ADDENDUM

PROJECT: Bryan Health
Bryan Medical Center, West
Independence Center, New Facility
Lincoln, Nebraska

AD-2

DATE ISSUED: Friday, March 22, 2013

② IC-STAIRS CC
1/2" = 1'-0"

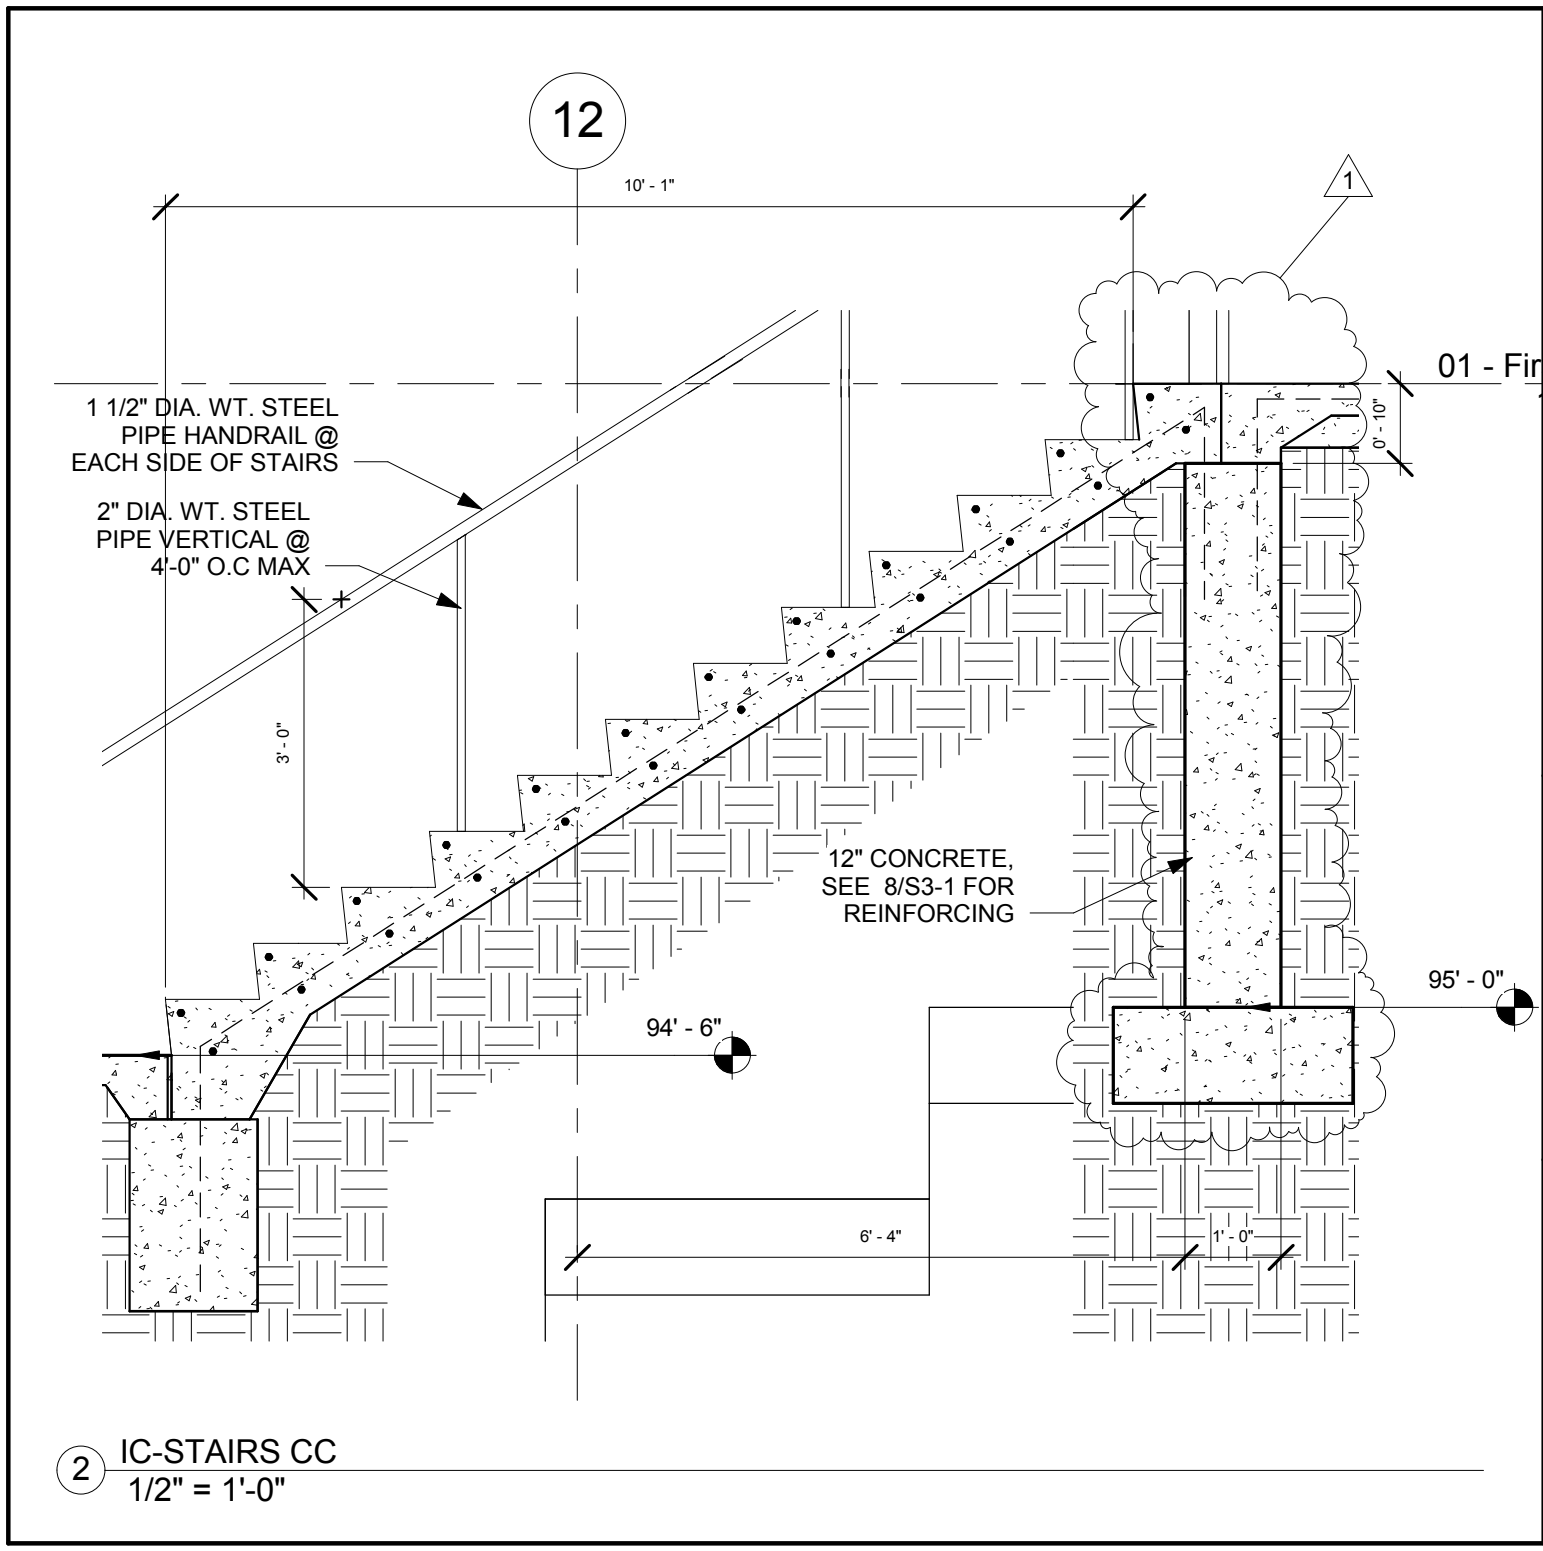
In reference to sheet **A5-3 – IC Stair CC**, revise Section 2 as indicated in Supplemental Drawing A5-3.1 attached.

Issue Date	03-22-2013
Job #	11-0101
Drawn by:	kas
CADD file:	A6-1
COPYRIGHT © DAVIS DESIGN ALL RIGHTS RESERVED	
Drawing Title Revisions to Elevation 32 and Addition of Detail 40	
From Sheet:	A6-1 for CA use:
Drawing #	A6-1.1

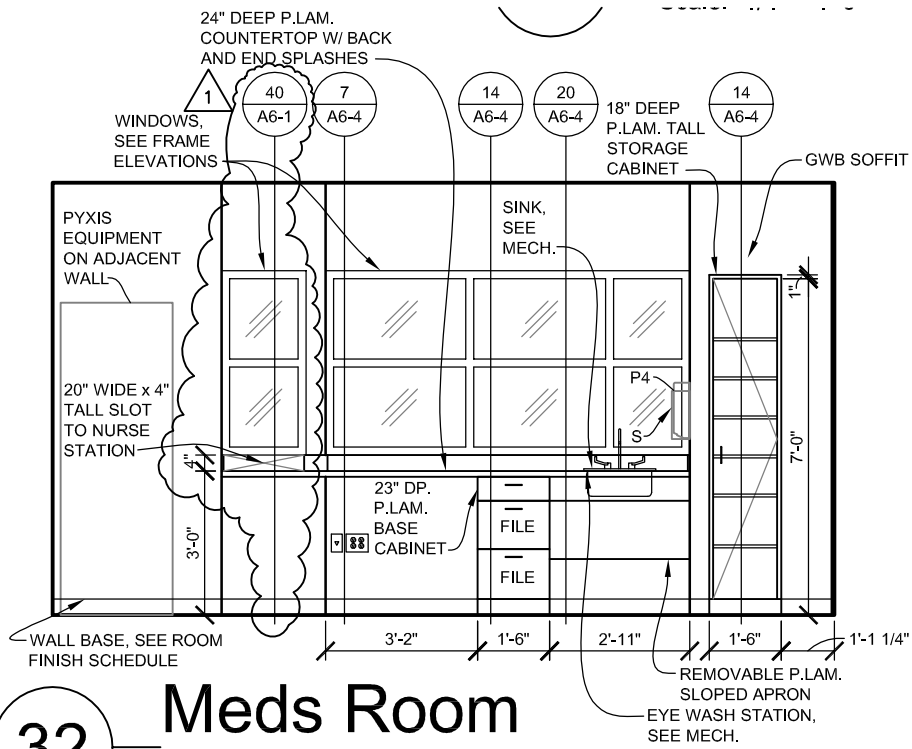
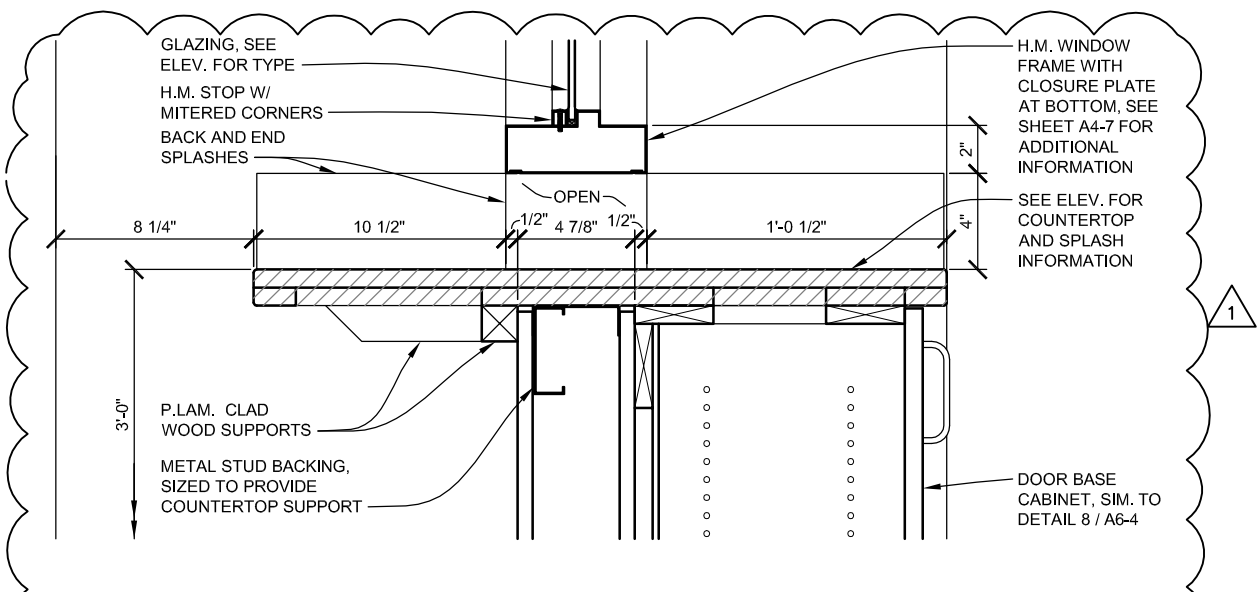
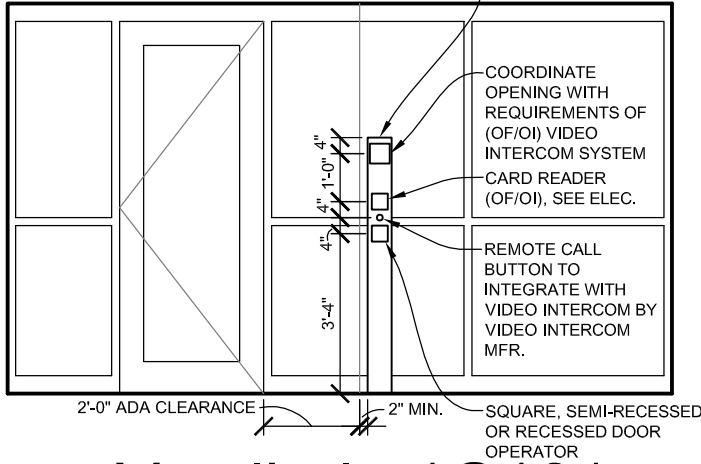
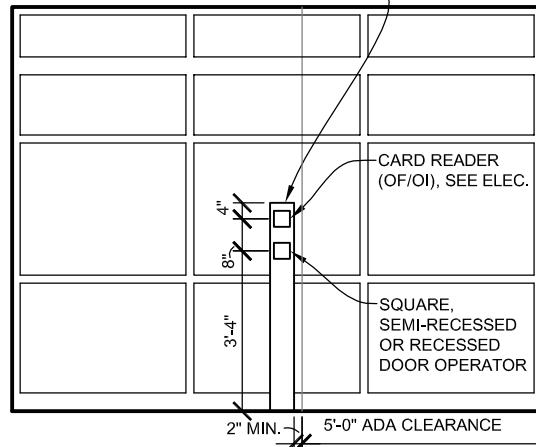
In reference to drawing sheet **A6-1 – Interior Elevations**, revise Elevation 32 and add Section Detail 40 and Elevations 41 & 42 as indicated in attached Supplemental Drawing A6-1.1 and A6-1.2.

Issue Date	03-22-2013
Job #	11-0101
Drawn by:	kas
CADD file:	A6-2.DWG
COPYRIGHT © DAVIS DESIGN ALL RIGHTS RESERVED	
Drawing Title	
Revision to Elevations 27, 29 & 30	
From Sheet:	for CA use:
A6-2	
Drawing #	
A6-2.1

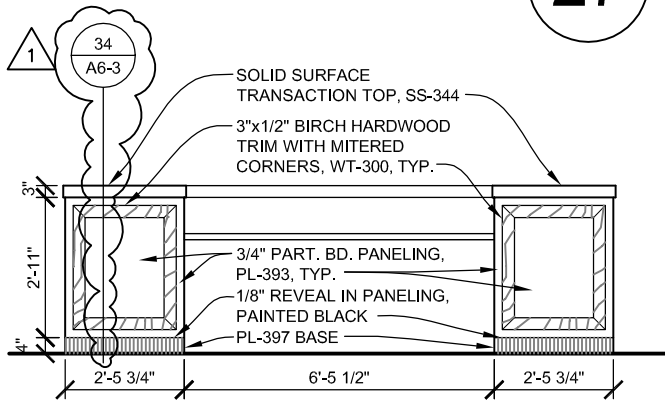
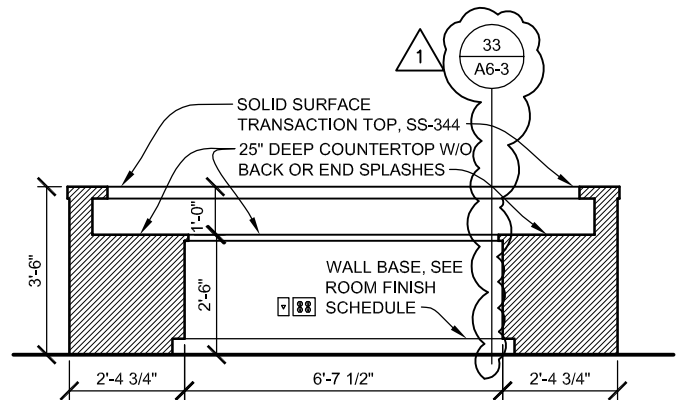
In reference to drawing sheet **A6-2 – Interior Elevations**, revise Elevations 27, 29 and 30 as indicated in attached Supplemental Drawing A6-2.1.

Issue Date	03-22-2013
Job #	11-0101
Drawn by:	kas
CADD file:	A6-3.DWG
COPYRIGHT © DAVIS DESIGN ALL RIGHTS RESERVED	
Drawing Title Addition of Detail 33	
From Sheet:	A6-3
for CA use:	
Drawing #	A6-3.1

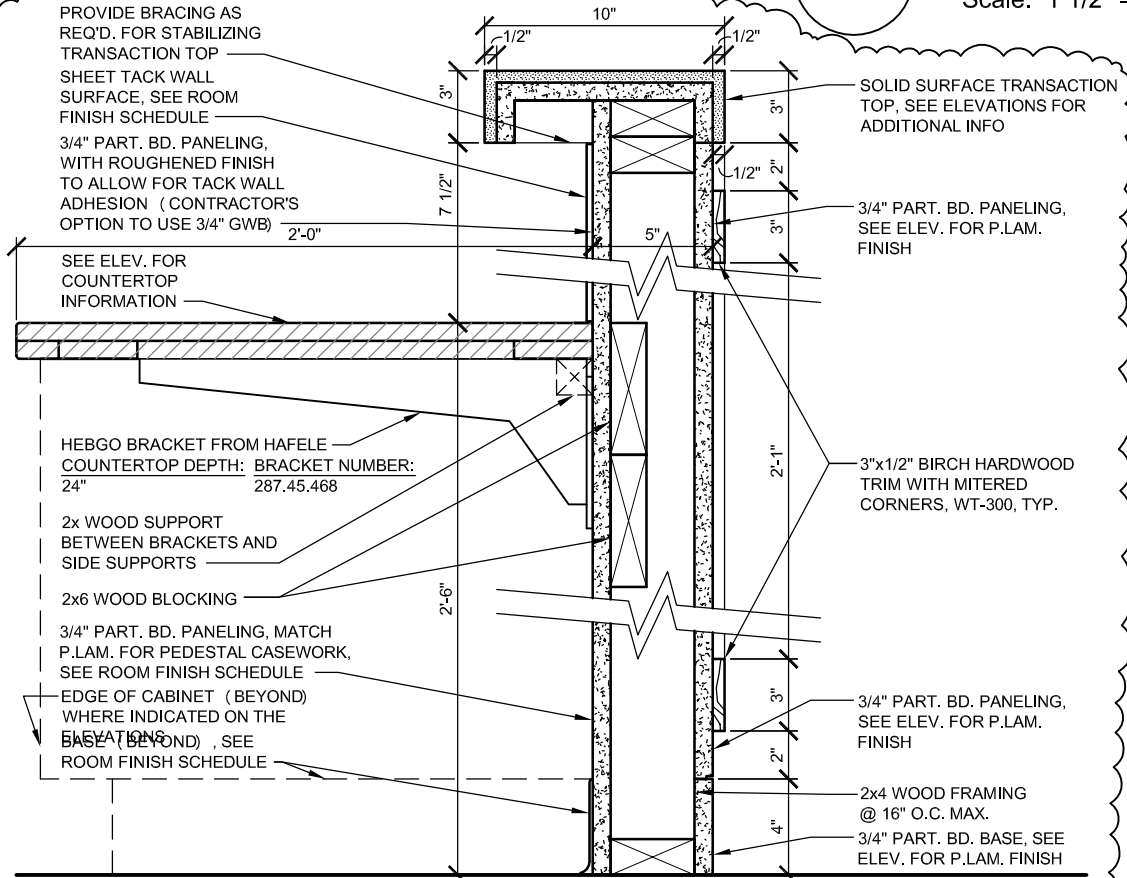
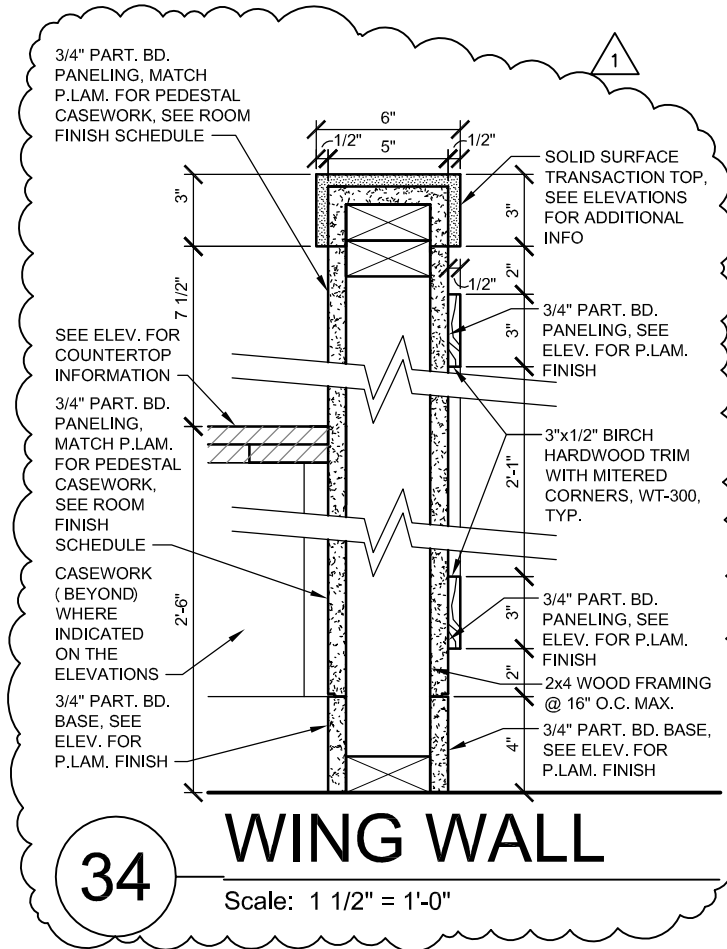
In reference to drawing sheet **A6-3 – Interior Elevations**, add Details 33 and 34 as indicated in attached Supplemental Drawing A6-3.1 and A6-3.2.

4 Bathroom Ceiling Plan
1/4" = 1'-0"

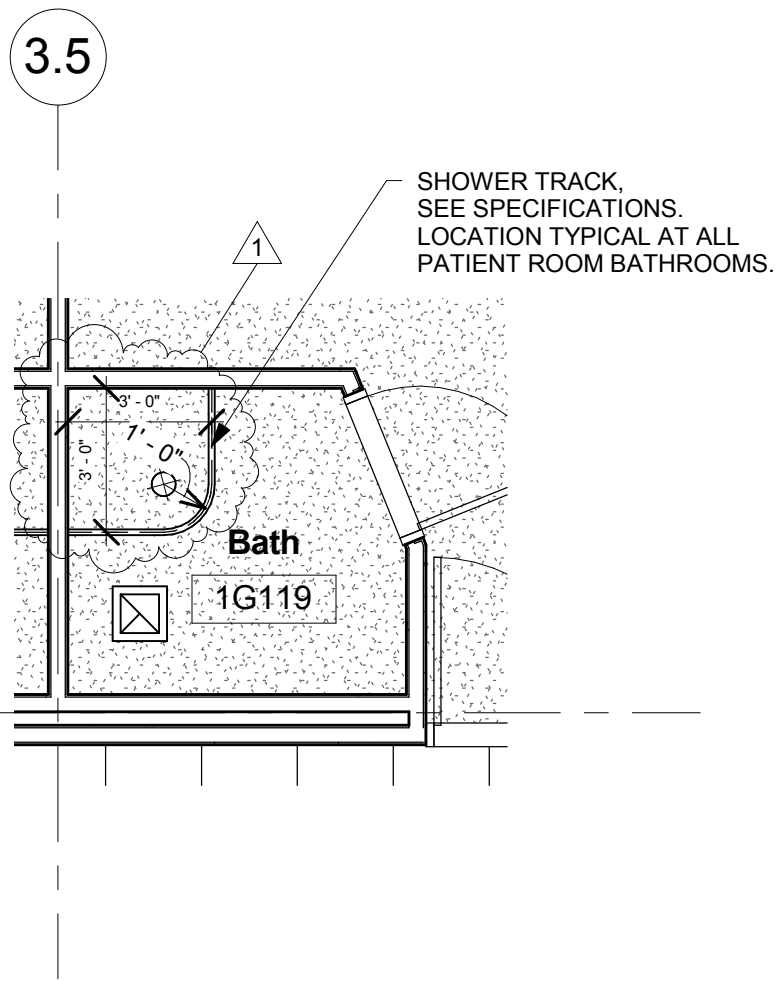
In reference to drawing sheet **A7-1G – Ceiling Plan**, add Bathroom Ceiling Plan as indicated on drawings A7-1G.1 Roof Hatch for plan revisions.

In reference to drawing Sheet **A7-1G**, to clarify, cubicle curtain tracks shall be installed in all sixteen (16) Patient Bathrooms. See Supplemental Drawing 7-1G.1 for configuration and dimension of curtain track to occur in each room.

Checked By: [Signature]
Drawn By: [Signature]
SHEET TITLE
Basement
Level Power
and Systems
Plan - Area G
SHEET NUMBER
E2-0G

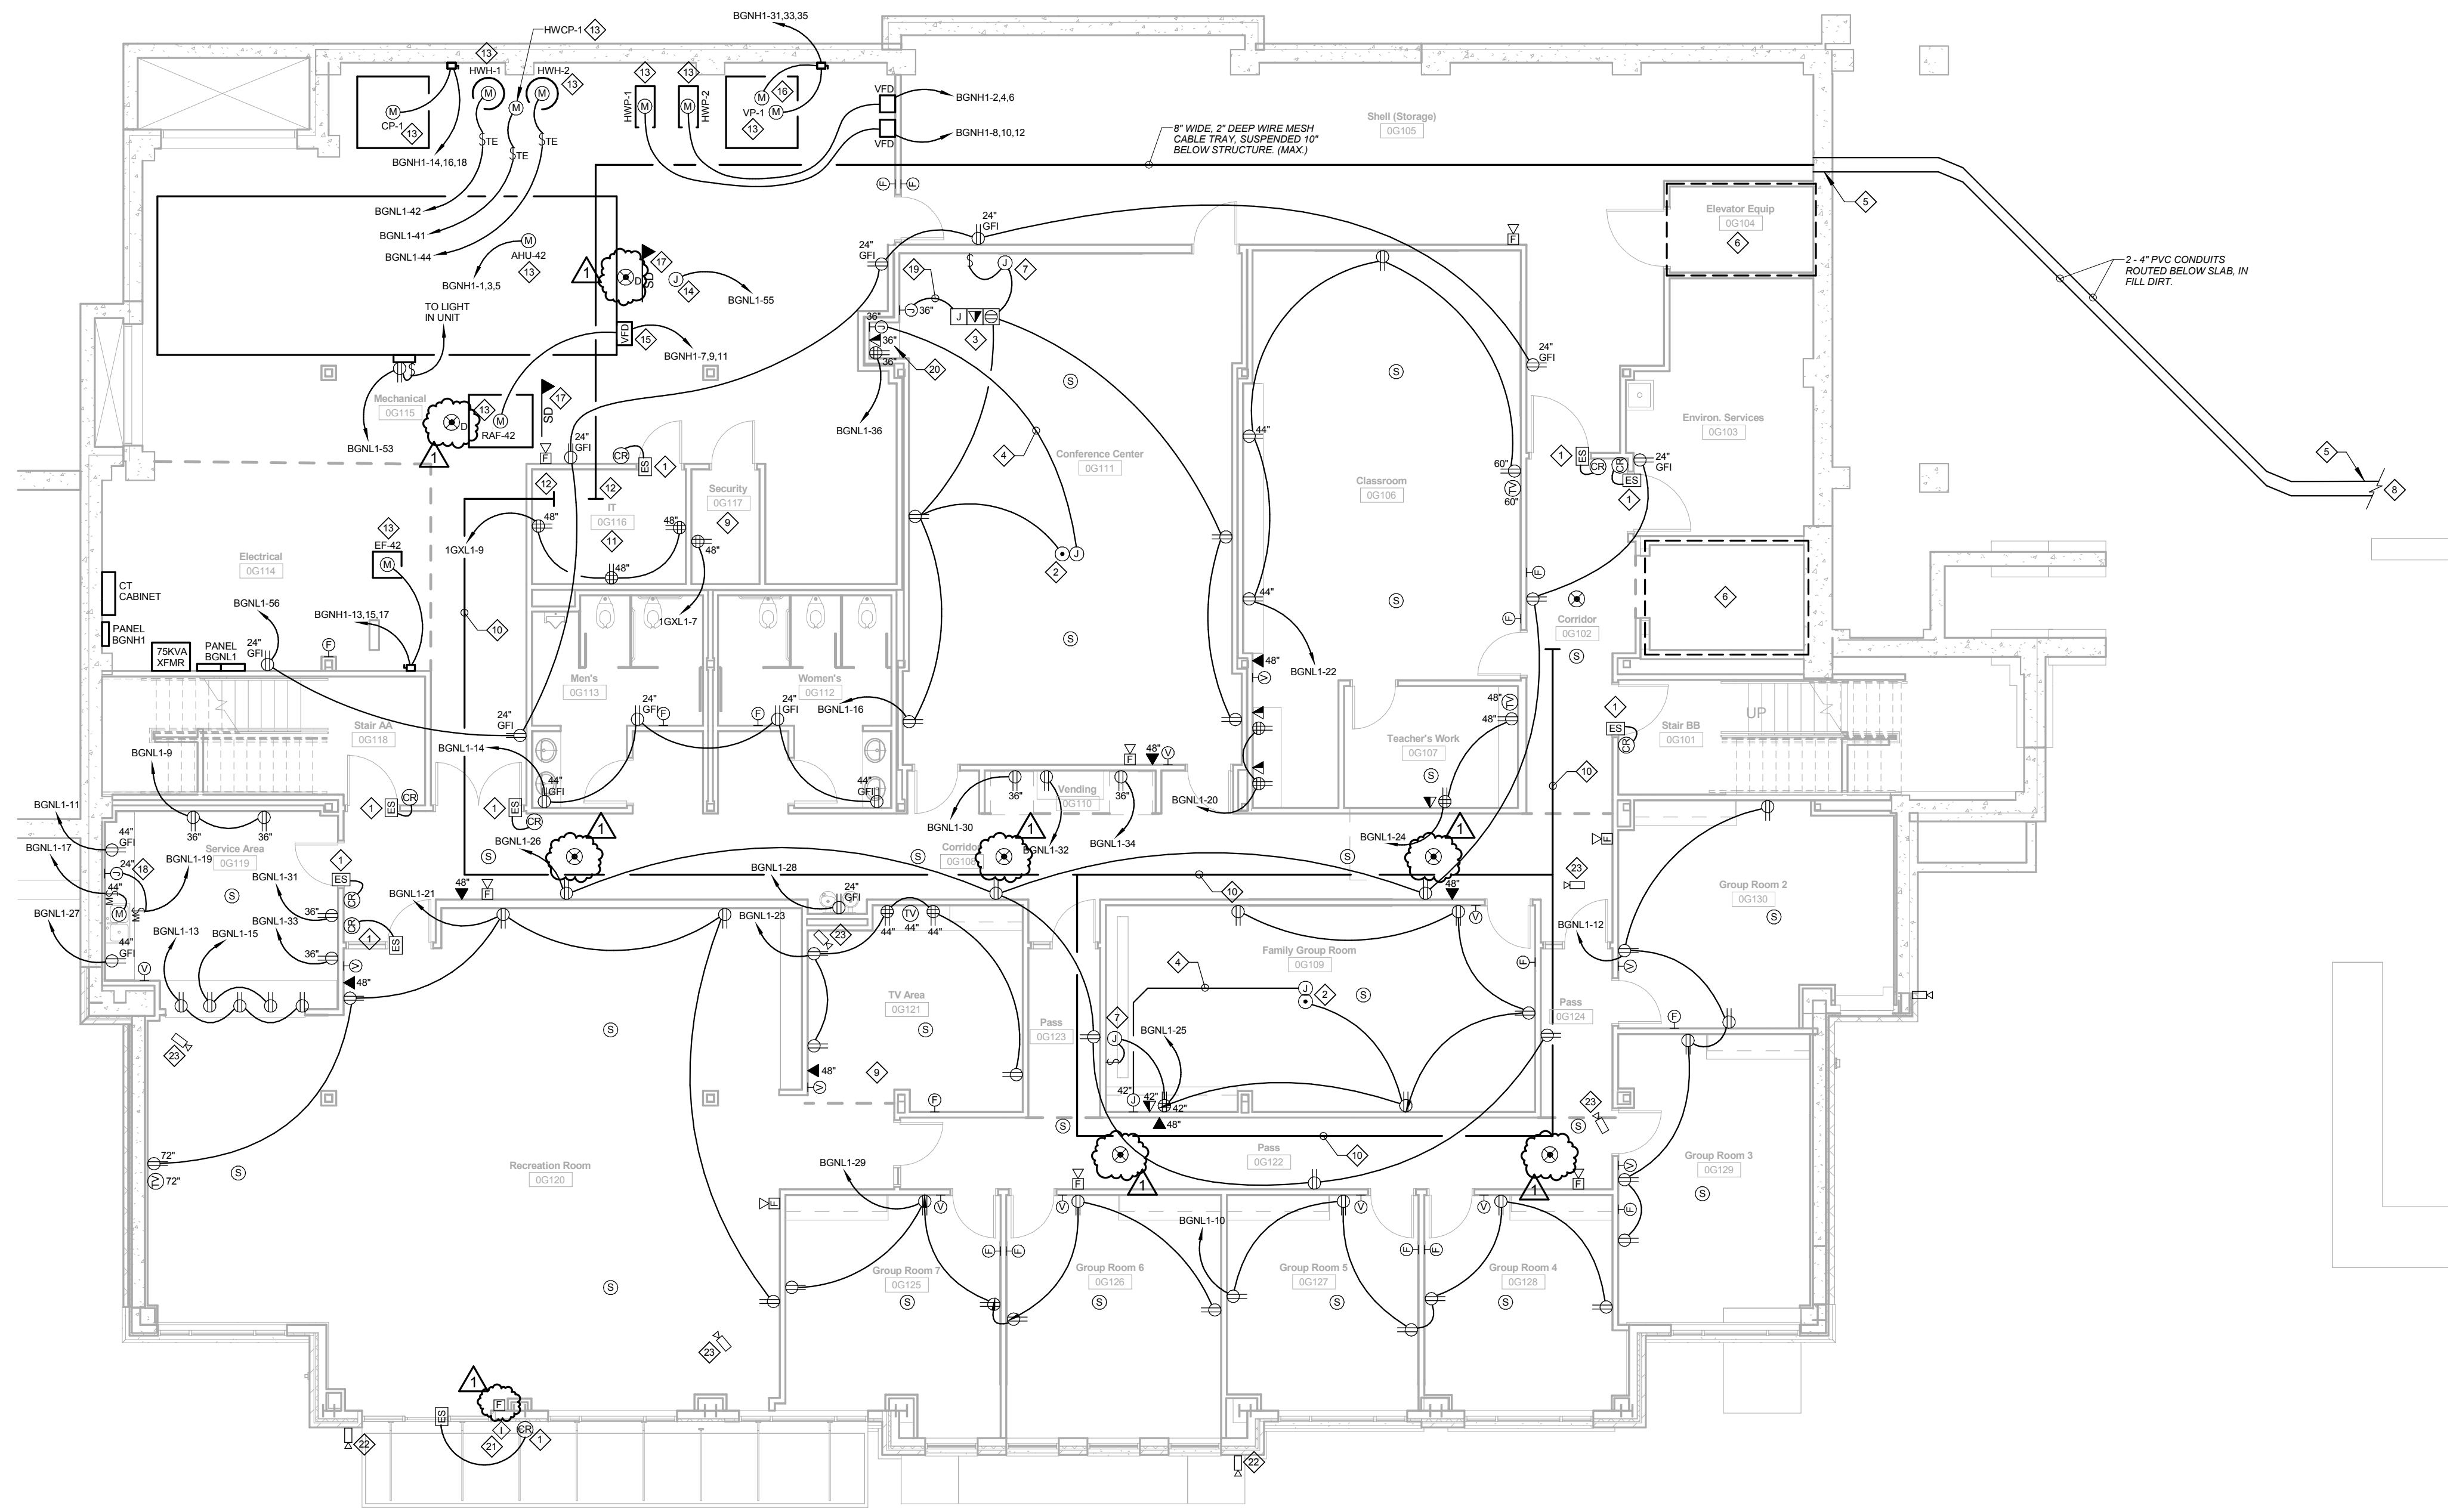
In reference to drawing Sheet E2-0G, Basement Level Power and Systems Plan – Area G, see attached plan E2-0G for revisions to add fire alarm devices. Note that this is a revised full size sheet.
